Crystal River Nuclear Plant
Docket No. 50-302
Operating License No. DPR-72

Subject: Crystal River Unit 3 – Relief Request #07-003-RR, Revision 1, and Response to Request for Additional Information

RELIEF REQUEST #07-003-RR, REVISION 1

USE OF WELD OVERLAYS AS AN ALTERNATIVE REPAIR TECHNIQUE

Fig. 2 Preservice and Inservice Examination Volume

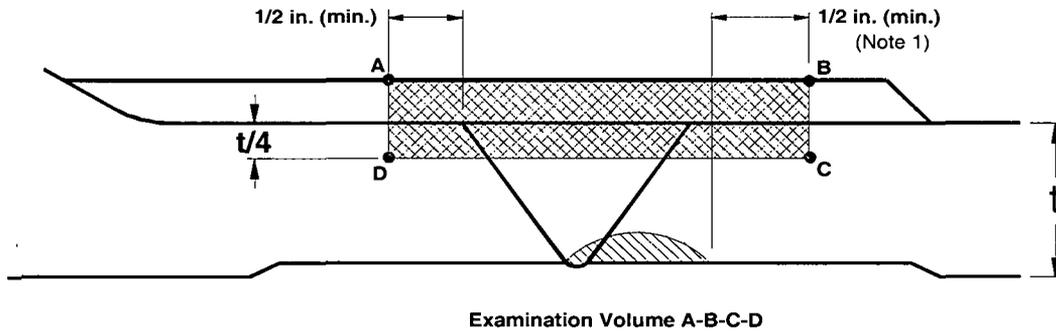
- c) Code Case N-740-1, Draft February 2007 is not explicit on examination requirements associated with an Alloy 600 safe end SWOL. The figures generally depict examination volumes associated with the weld. What acceptance examinations, preservice examinations, and inservice examinations are planned for the SWOL of the Alloy 600 safe end and what are the volumes to be examined?**

Figure 1; High Sulfur Stainless Pipe Exhibiting Alloy 82 (ERNiCr-3) Deposit Between Alloy 182 (ENiCrFe-3), ER309L, and Alloy 52M (ERNiCrFe-7A) Deposits.

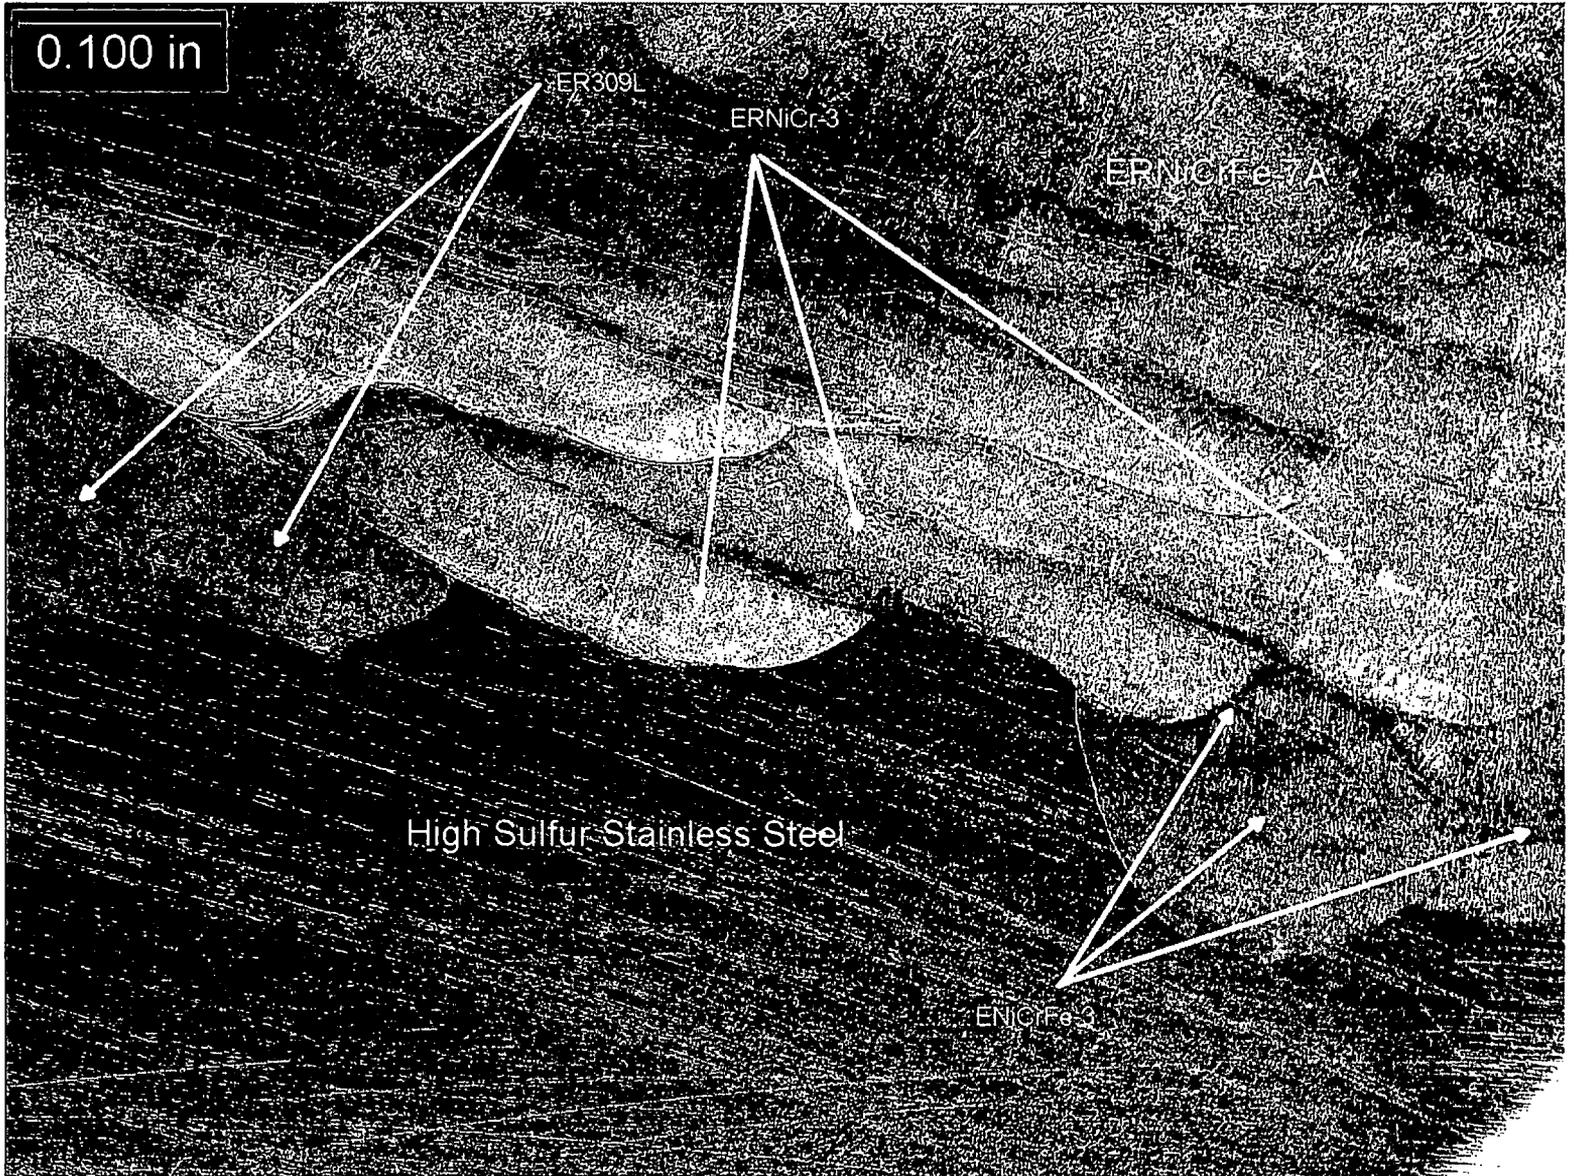
Initial metallographic examination searching for any type of discontinuity, flaw or other anomaly (single specimen with “rough” polish and etch) has been performed on the first specimen. See Figure 1.
